Here are my feedbacks on the MIG-29S model you released as a beta version, in a more "readable" format. Note that I left the links to our web server so you can see the pictures in higher definition if needed.

Slat1

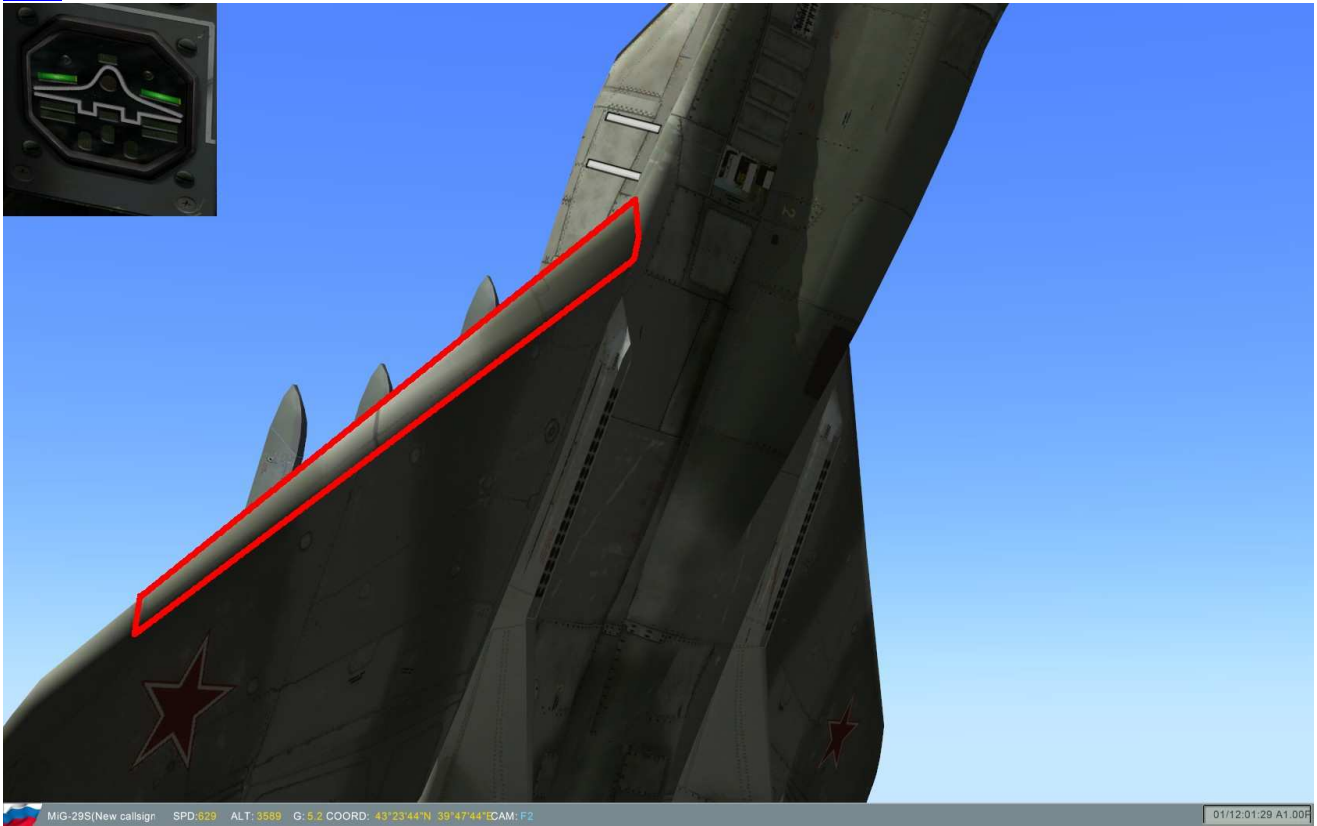
b) The slats (moving leading edge).

In your model, you chose to link the animations of the slats with the flap extention/retraction. It works well but in reality and in ED model, the slats get extended above a certain angle of attack (even if the flaps are retracted). Is there a reason why you chose to animate the flaps the way you did?

a) Side view

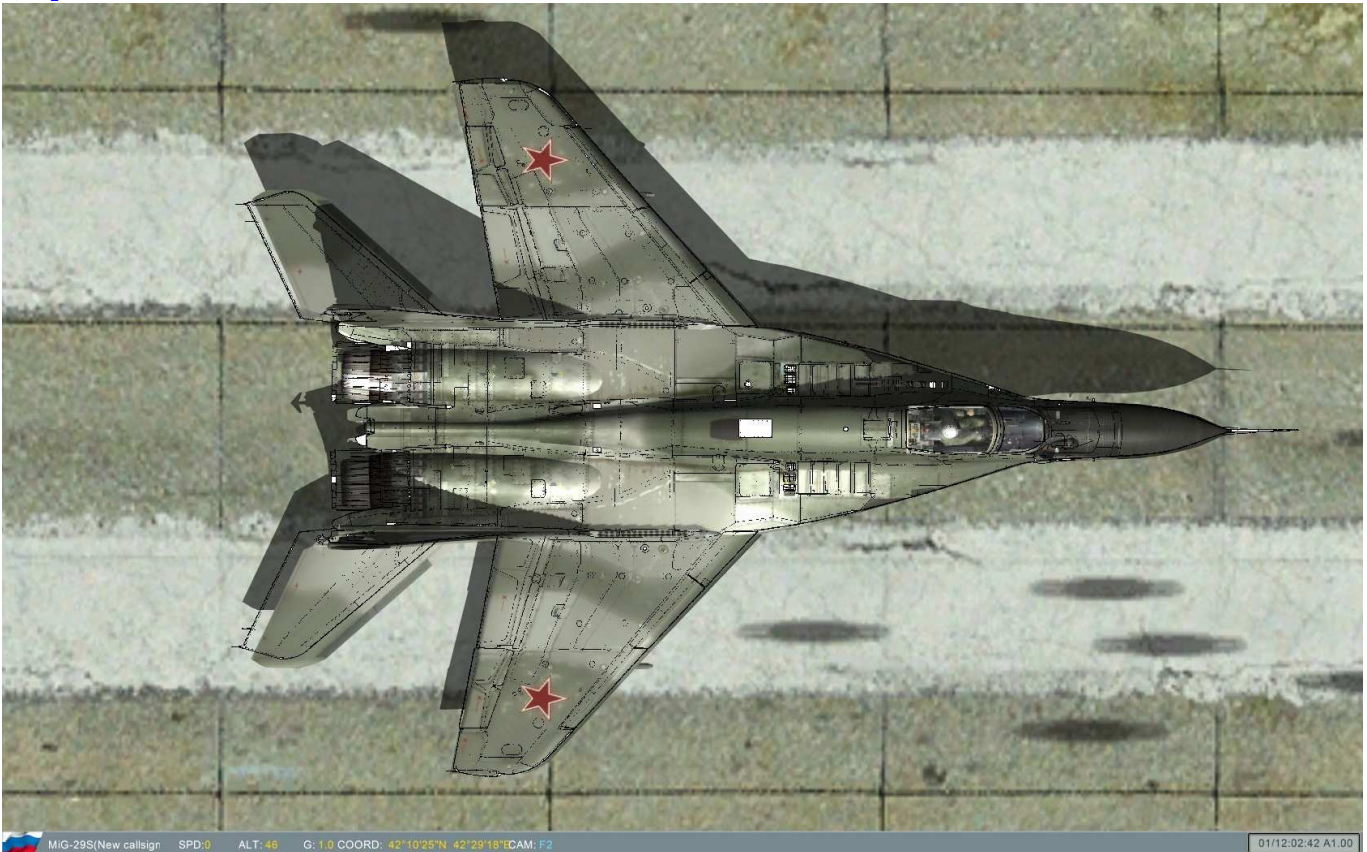
Here we can see that the nose is pointing too much down (a bit) but mainly the problem is the cockpit that is to high. If the cockpit came down at the right position, the nose would be almost perfect and the back would no more be too round.

The tails shape could be adjusted as well.

Also, note that the antenna on the back is missing.

Airbrake

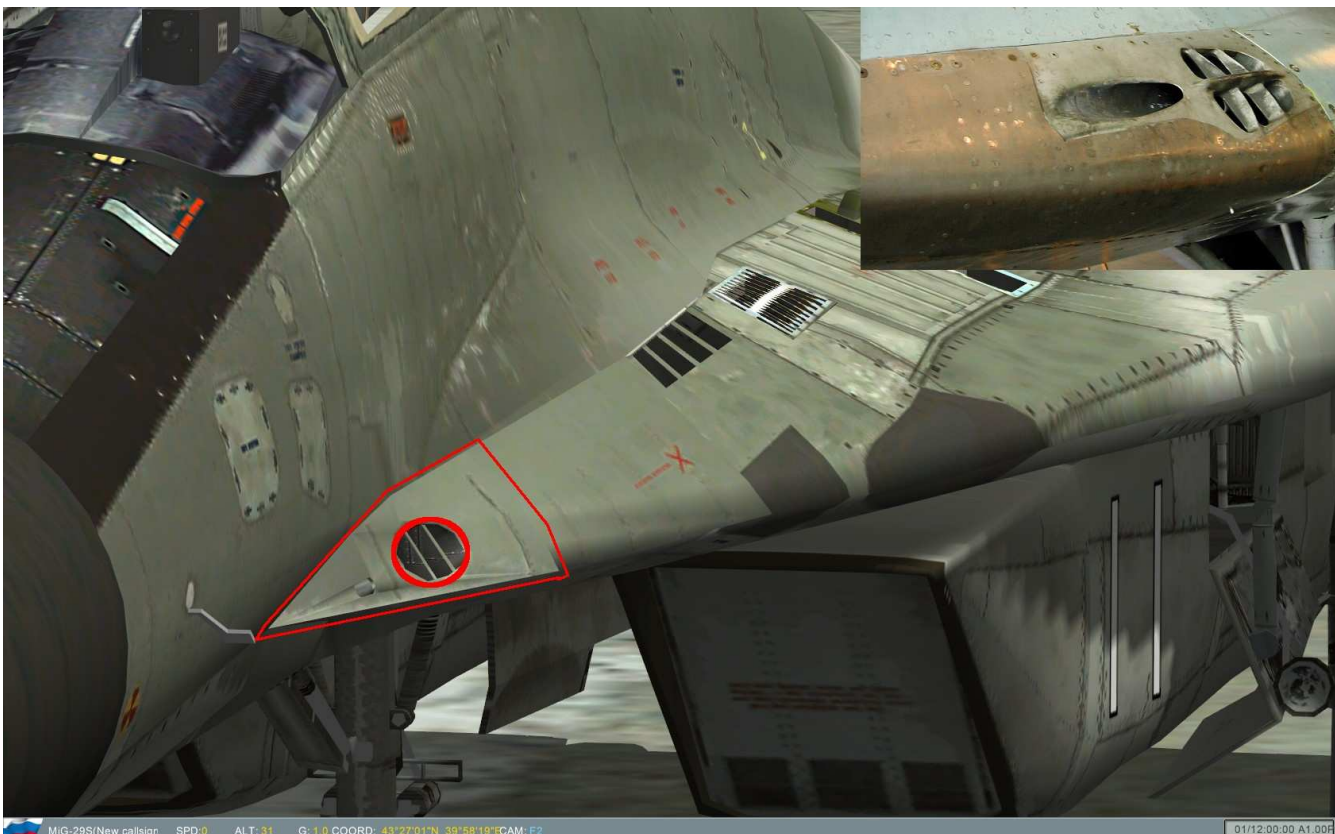
f) The Airbrake and generaly: the back of the plane:

The back of the plane is not accurately designed. Actualy there is like a "cylinder which is not there on the real plane. It looks like a mix between the MIG-29 and the SU-27. (Also the parachute case diameter maybe a bit to big)

Gun and Apex leading edge

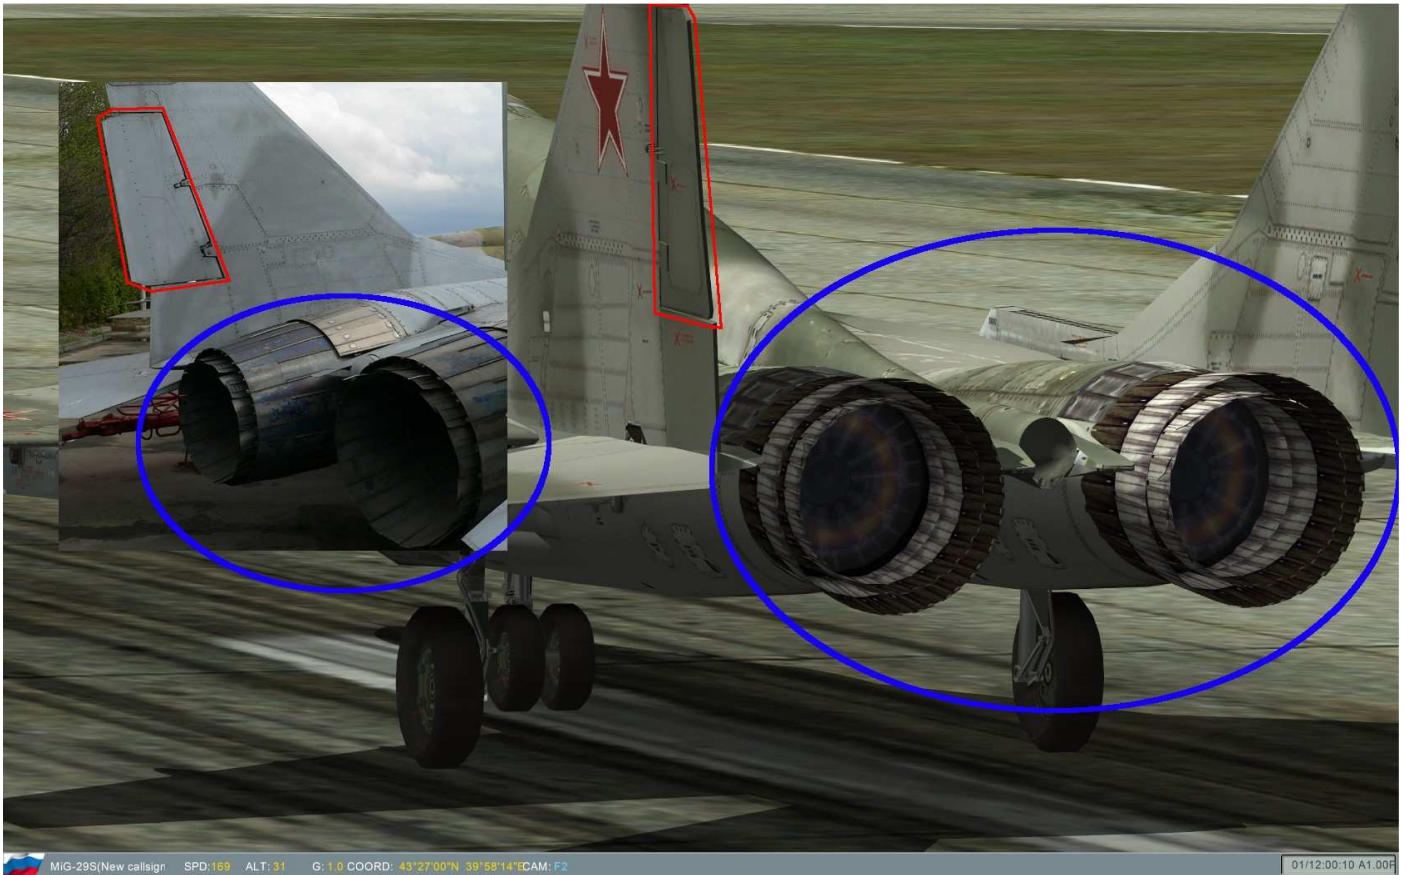
g) The gun and the the apex junction to the airplane body:

The Apex leading edge should be curved all the way long. It is the case on your model except at the gun area where it becomes extremely sharp. Also, the gun "exhaust" could be improved. See picture below that illustrate my point.

Rudder and Nozzles

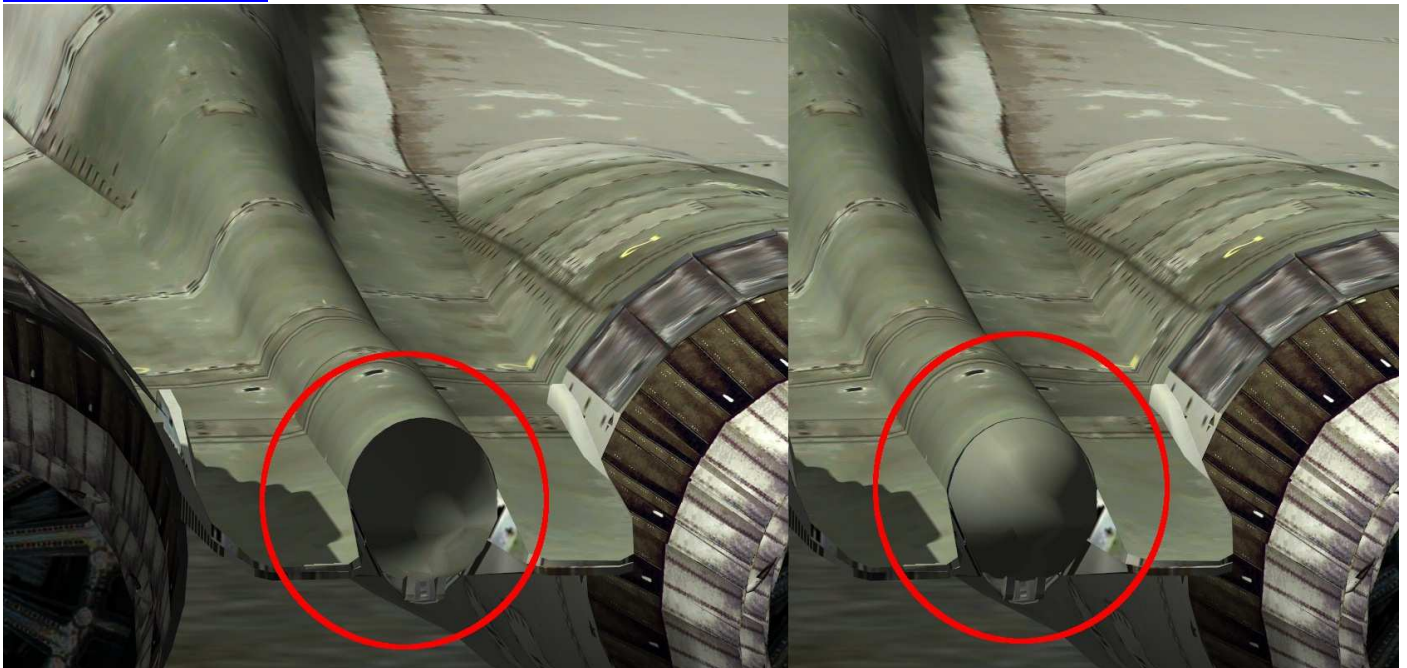
h) The Rudder and engine nozzles:

The engine nozzles are getting to wide open in full afterburner and the rudder plates should be larger See picture below:

j) The vertical tails and flare/chaff dispensers.

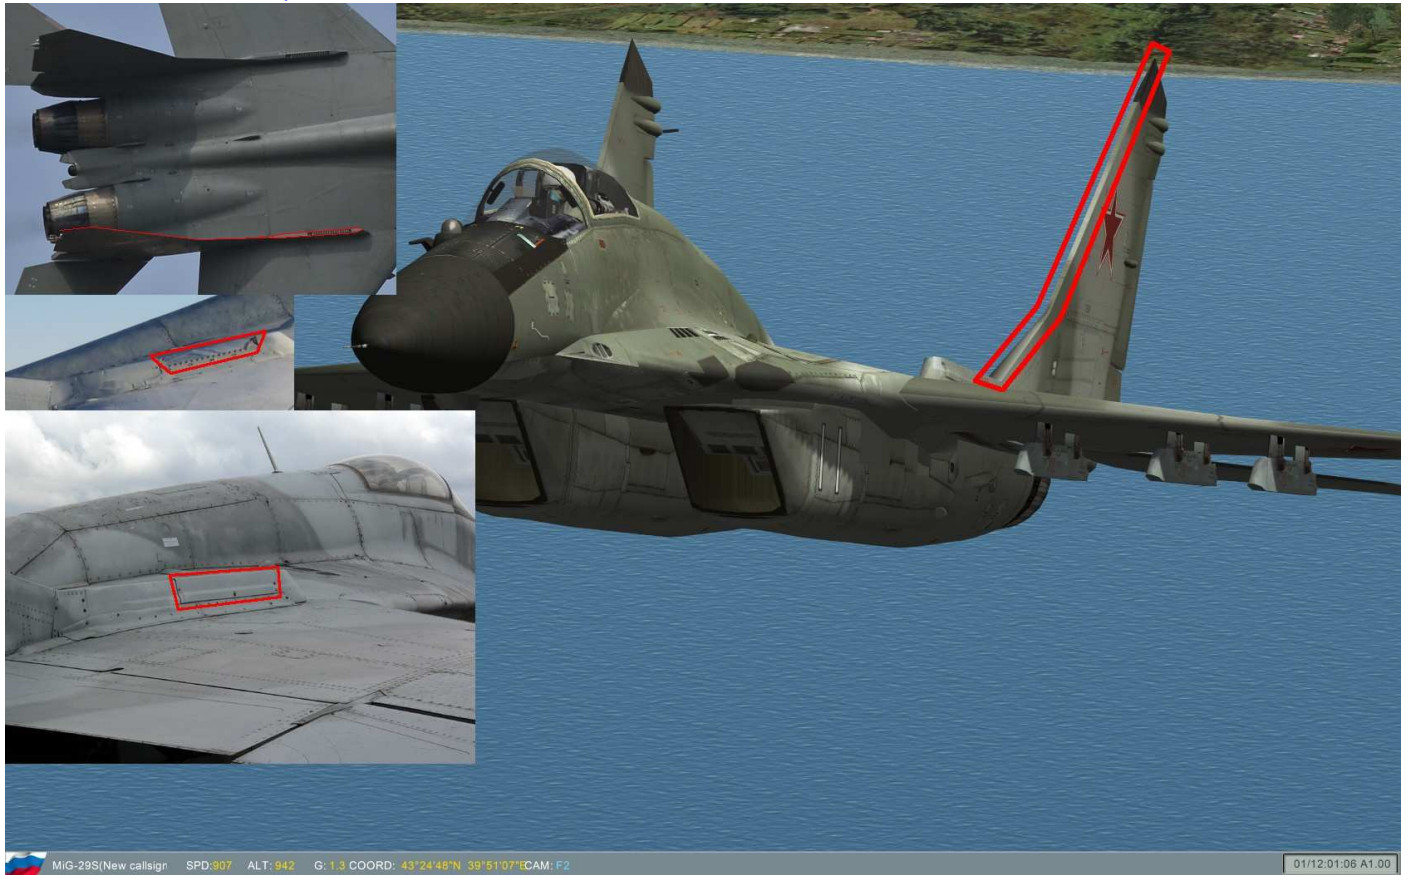
The leading edge of the tails is too thick. Is should be very sharp and getting wider only at the flare/chaff dispenser level. Also, even if the strcture of the the dispenser is OK, the texture showing the flare/chaff cartridges is too long: in reality, it is much shorter (about half of the length of the structure i would say).
Tails and flare/chaff dispensers.

p) I think I found the source of the airbrake/back problem (described in section II-f)

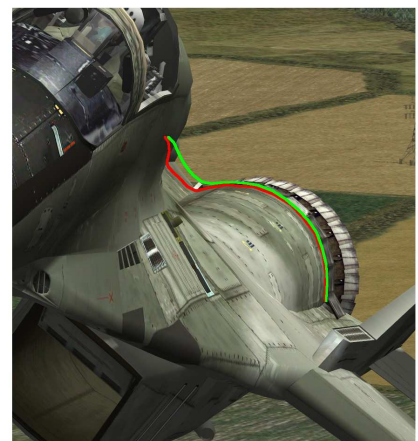
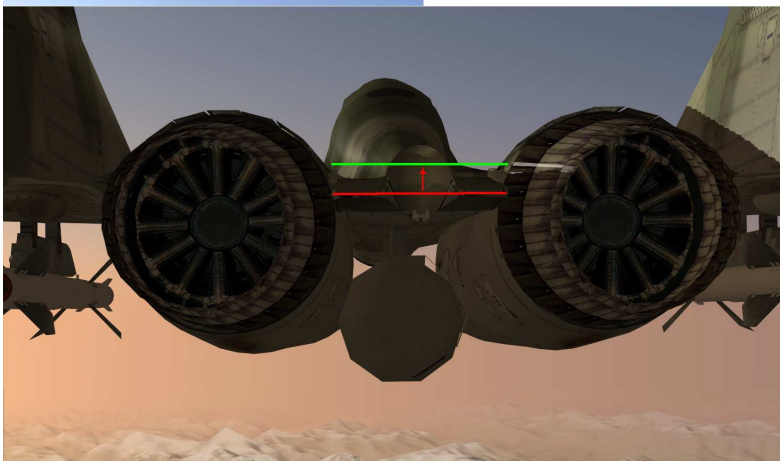
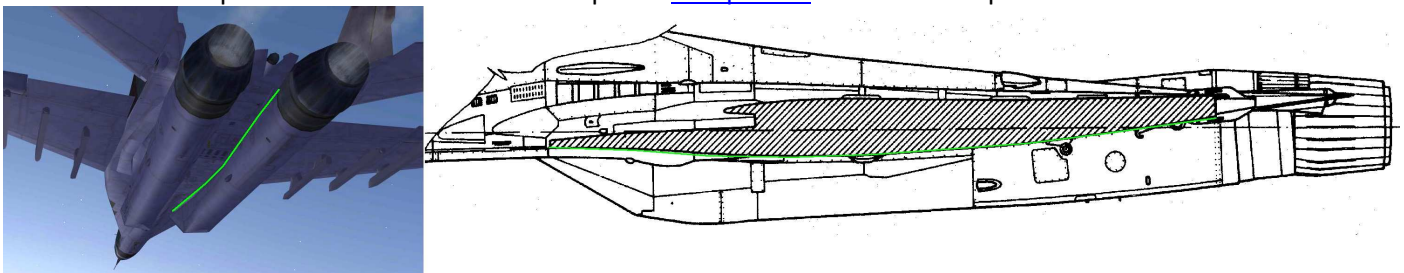
In fact, the belly of the mig is "curved" but you actually did it "flat". Because of that, you airbrake is a bit to low which induces shape mistakes on the back of the plane. This picture illustrates the problem:

In green is what I believe to be the right shape (top left is ED MIG-29), in Red is your model.
